Series 90 100 cc Axial Piston Motor

Parts Manual

Service Bulletin: SB-1988-018

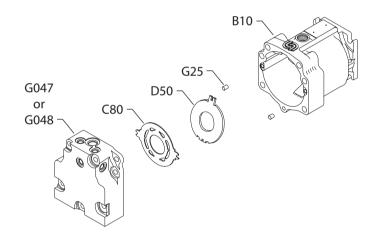
Dowel pin change

A product change has occurred on Series 90 75 cc and 100 cc fixed displacement motors.

The dowel pins (item G25) have increased in diameter from 1/4" to 3/8". With this change, the dowel pin hole diameters in the end cap (item G047 or G048), housing (item B10), and the valve plate (item C80) have also changed. In addition, the thrust plate (item D50) in the 100 cc fixed displacement motor has also changed to fit the new housing.

This change creates spare parts non-interchangeability among all of the above mentioned parts. All of the affected parts remain available for the repair of any vintage Series 90 fixed motor. Refer to the date code portion of the serial number on the name plate of the motor being repaired when ordering parts.

Qty/	75 cc	75 cc	100 cc	100 cc
Item*	Motor	Prior to 88-43	From 88-43	Prior to 88-23	From 88-23
G047	1	8100233	8100306	8200123	8200152
G048	1	8100232	8100279	8200122	8200151
C80	1	8100095	8100278	8200103	8200134
D50	1	No Change	No Change	8200014	8200167
G25	2	9004800-2512	9004800-3708	9004800-3116	9004800-3708
B10	1	8100252	8100465	8200099	333641

Service Bulletin: SB-1999-036

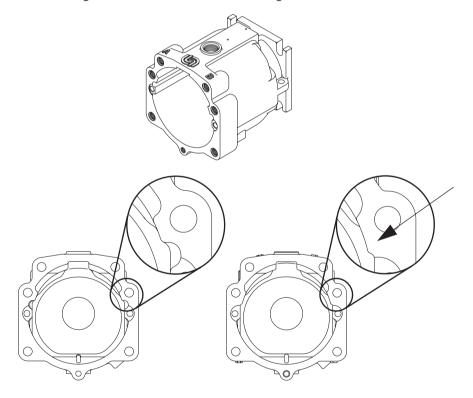
Motor housing change

Sauer-Danfoss has introduced a design change to the motor housings used on all series 90 100cc fixed displacement motors. The housing strength has been increased in the area of the casting ribs, by increasing the size of the rib. This change will reduce the potential for cracking the rib of the housing when tightening the two shorter end cap bolts.

To assist in identifying this change, Sauer-Danfoss has released a new housing part number. The new housing is completely interchangeable with the previous housing. The previous housing has been obsoleted and is no longer available.

Description	Previous	New
	Housing	Housing
motor housing - MF	8200230	8200447

Service Bulletin: SB-2000-047

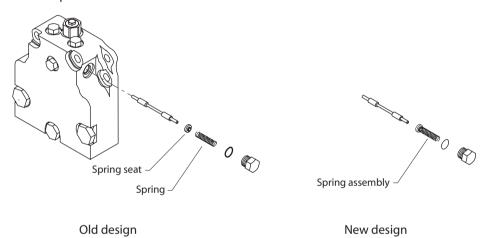
Loop flushing spring and spring seat change

As a product improvement, Sauer-Danfoss has changed the design of the spring and spring seat for the series 90 42cc, 55cc, 75cc, and 100cc fixed and variable displacement motors. The old design used a separate spring and spring seat. The new design incorporates the two parts into a one piece assembly. This makes the assembly of the spring and spring seat onto the spool much easier than the previous design.

Since the new spring assembly has a high spring rate than the previous spring, this is an interchangeable change only if both springs and spring seats are replaced at the same time. Sauer-Danfoss has issued a new part number for the spring assembly. The previous spring seat and spring remain valid service parts since they are used on other Sauer-Danfoss products.

Previous spring seat	Previous spring	New spring assembly
8800551	4350286	513596

Service Bulletin: SB-2001-011

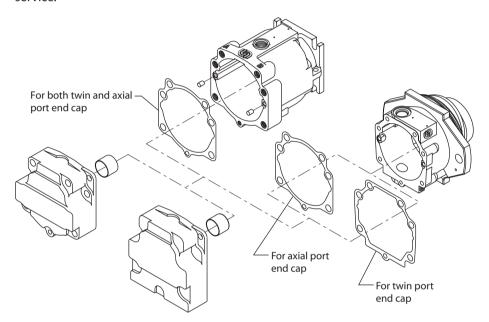
Change to end cap gasket material

The end cap gasket material has changed. Sauer-Danfoss has issued new end cap gasket part numbers. The previous part numbers are osolete. They are no longer available for service.

Frame size	Mounting flange	Previous end cap	New end cap
	(end cap porting)	gasket	gasket
55 cc	SAE (all), cartridge (axial)	8000167	8000721
55 cc	Cartridge (twin)	8000603	8000720
75 cc	SAE (all), cartridge (axial)	8100311	8100875
75 cc	Cartridge (twin)	8100749	8100874
100 cc	Sae (all)	8200102	8200511

Housing change to accept long screws

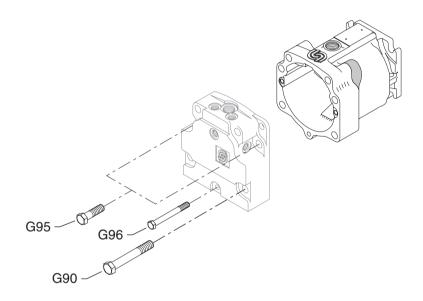
Sauer-Danfoss has changed the housing used in series 90 100 cc fixed motors. Material was added at the area of the two shorter end cap mounting screws (G95). The hole for these screws is now deeper to accept the longer screw (G90) that is used for the other four large end cap mounting screws. The six larger screws will have the same stretch and therefore the same clamping force for the gasket sealing area. The smaller end cap mounting screw (G96) remains the same. The "old" housing and the short screws will become obsolete and no longer available for service.

Description	Old part number	New part number
Housing	8200447	8200509
Screw (G95)	9007210-1609	9007210-1617

Service Bulletin: SB-2005-005

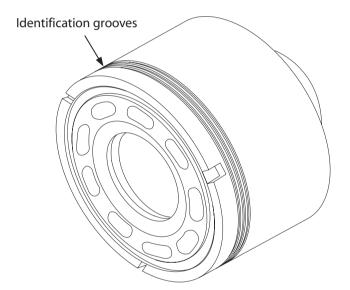
Cylinder block change

As a product improvement, Sauer Danfoss has added a special process to the spline area of the cylinder block used in series 90, 100 cc fixed displacement motors. Three identification grooves will be added to these blocks to indicate this change. All other dimensions of the cylinder block remain the same.

Production built variable pumps will still use the standard cylinder blocks, however cylinder block assembly service kits will contain the "special process" cylinder block, whether they will be used in pumps or motors.

New p/n
8200570
8510368
8510369
8510370
8510371
8510372
8200574
